## UNITED STATES PATENT AND TRADEMARK OFFICE

APPLICATION NO.	FILING DATE	FIRST NAMED INVENTOR	ATTORNEY DOCKET NO.	CONFIRMATION NO.
10/511,119	03/17/2005	Patrice Cardine	60130-2246	8871
26066 7500 12/11/2008 CARLSON, GASKEY & OLDS, P.C. 400 WEST MAPLE ROAD			EXAMINER	
			REDMAN, JERRY E	
SUITE 350 BIRMINGHAM, MI 48009			ART UNIT	PAPER NUMBER
			3634	
			MAIL DATE	DELIVERY MODE
			12/11/2008	PAPER

## Application No. Applicant(s) 10/511,119 CARDINE ET AL. Office Action Summary Examiner Art Unit Jerry Redman 3634 -- The MAILING DATE of this communication appears on the cover sheet with the correspondence address --Period for Reply A SHORTENED STATUTORY PERIOD FOR REPLY IS SET TO EXPIRE 3 MONTH(S) OR THIRTY (30) DAYS. WHICHEVER IS LONGER, FROM THE MAILING DATE OF THIS COMMUNICATION. Extensions of time may be available under the provisions of 37 CFR 1.136(a). In no event, however, may a reply be timely filed after SIX (6) MONTHS from the mailing date of this communication. If NO period for reply is specified above, the maximum statutory period will apply and will expire SIX (6) MONTHS from the mailing date of this communication - Failure to reply within the set or extended period for r

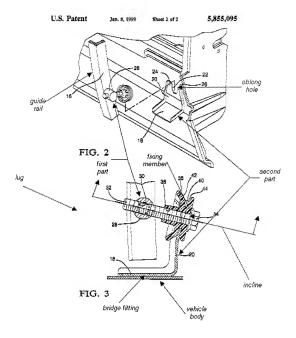
As best understood, claims 1-23 are rejected under 35 U.S.C. 102(b) as being anticipated by Dedrich et al., (5.855,095). As shown in detail below. Dedrich et al., (5,855,095) disclose having a first "twisted"/bent part connected to a guide rail which moves a window pane between an open and closed position, a second "planar" part fixed to the vehicle body (at 18) and having an oblong hole (22) for passage of a fixing member (34), and a bridge fitting (see figure below). Furthermore, since the guide rail is Application/Control Number: 10/511,119

curved and the window opening and closing path is curved (i.e., guiding direction), then the second part defining a plane and a normal line is substantially perpendicular to the plane and inclined relative to the guiding direction.

The applicant's argument have been considered but are not deemed persuasive. The applicant argues that claim 1 now clearly defines the normal line is inclined relative to a window guiding direction. As stated in detail above, the window guiding direction is slightly curved so that there are many "normal lines" along the path of the window guiding direction. The applicant further argues that the first and second parts are a "single element" which is not readily understood by the Examiner as stated above.

When the first and second parts of Dedrich et al. are attached together, they form a "single component". Still furthermore, the second part of Dedrich et al. is of an L-shape and therefore defines "two planes" and not just a single plane as recited in the applicant's arguments
